A/H10/95

**Layout Plan Submission
for Permitted "Office", "Exhibition or Convention Hall",
"Information Technology and Telecommunications Industries"
"Eating Place", and "Shop and Services" Uses,
for Cyberport Expansion in "OU(Cyber-Port)(1)" Zone
at Telegraph Bay, Pok Fu Lam, Hong Kong
- Section 16 Planning Application No. A/H10/95 -**

Comments on Cyberport expansion plan A/H10/95 [#1110] 對數碼港擴建的意見
-A/H10/95

Annex 1 - THE BULK OF THE BUILDING HAS INCREASED DRAMATICALLY 新大樓的體積相比原方案明顯增大了

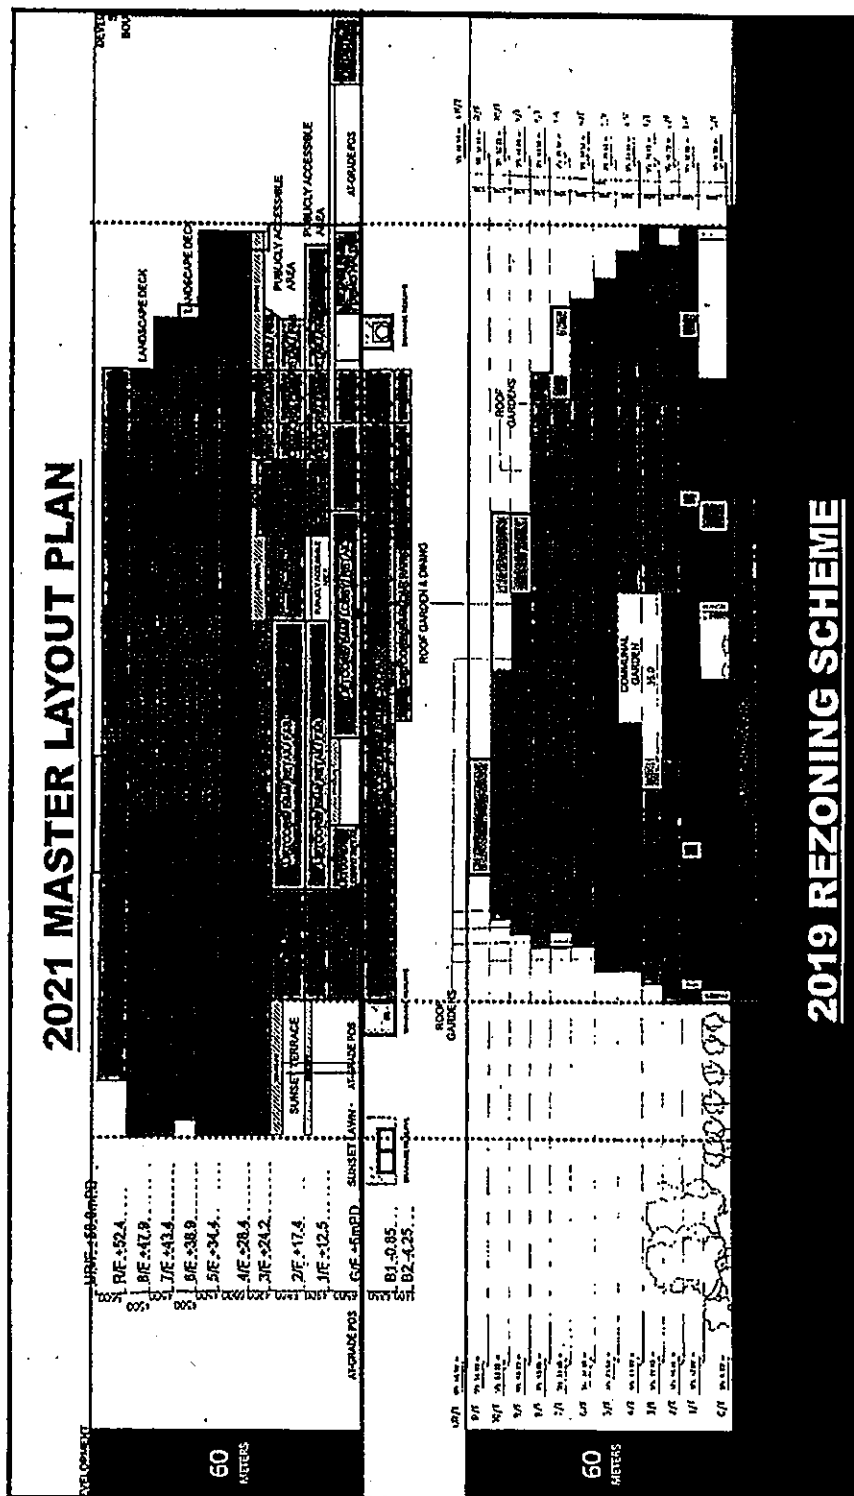
- 12. With the Urban Design Guidelines stipulating "*Descending and varying building height profile along the waterfront*" we urge the Town Planning Board to ensure that the height of Cyberport 5 is lower than the structures which lie behind it. The Urban Design Guidelines stipulate descending building height with taller buildings inland and lower buildings on waterfronts.
